Monthly Specification Update

Intel® Server Board S5520UR

Intel Order Number E69054-001

Aug 2011

Figure 1. Removing the Heatsink

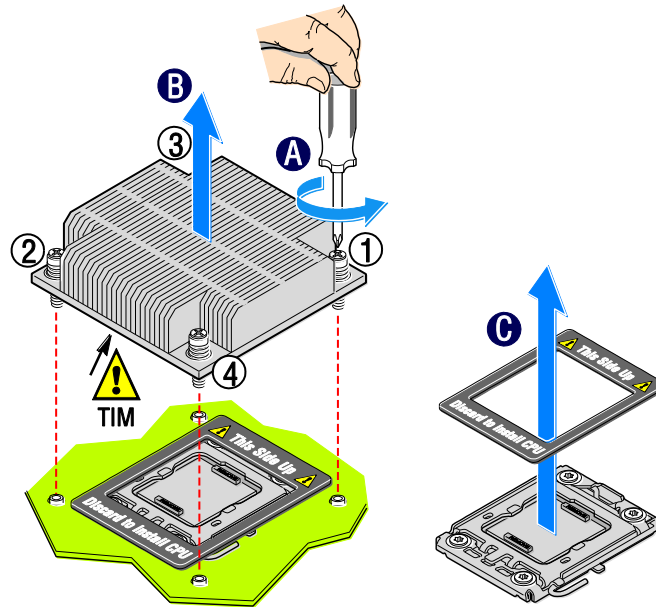
1. Proper Heatsink Installation and Removal Instructions are missing from Service Guide

Problem: The current documentation does not properly describe the installation and removal of the heatsink. Careful insertion and removal of the heatsink is required to prevent damage to the heatsink screws or backplate.

1. Loosen the four captive screws on the heatsink corners in a diagonal manner according to the numbers shown in figure 1 as follows:
 - Starting with the screw at location 1, loosen it by giving it **two rotations** in the anticlockwise direction and stop. (**IMPORTANT:** Do not fully loosen.)
 - Proceed to the screw at location 2 and loosen it by giving it two rotations and stop.
 - Loosen screws at locations 3 and 4 by giving each screw two rotations and then stop.
 - Repeat steps 1a through 1c by giving each screw two rotations each time until all screws are loosened.
2. Do one of the following:
 - If removing the heatsink for the first time, do the following:
 - i. Lift the heatsink from the board.
 - ii. Remove and discard the spacer (see letter “C” in figure 1).

Workaround: Perform the steps outlined below for installation and removal of the heatsink to avoid damage.

Figure 2: Installing the Heatsink

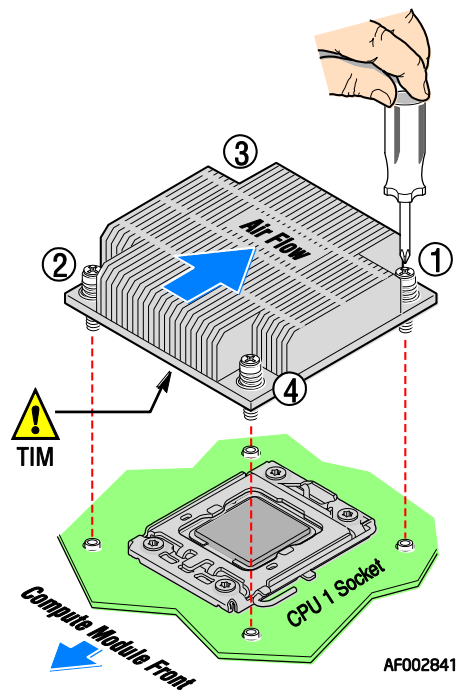
2. Orient the heatsink over the processor as shown in Figure 2. The heatsink fins must be positioned as shown to provide correct airflow through the system.

3. Set the heatsink over the processor, lining up the four captive screws with the four posts surrounding the processor.
4. Loosely screw in the captive screws on the heatsink corners in a diagonal manner according to the numbers shown in Figure 2 as follows:

- a. Starting with the screw at location 1, engage the screw threads by giving it **two rotations** in the clockwise direction and stop. (**IMPORTANT:** Do not fully tighten.)

- d. Repeat steps 4a through 4c by giving each screw two rotations each time until all screws are lightly tightened upto a maximum of 8 inch-lbs torque.
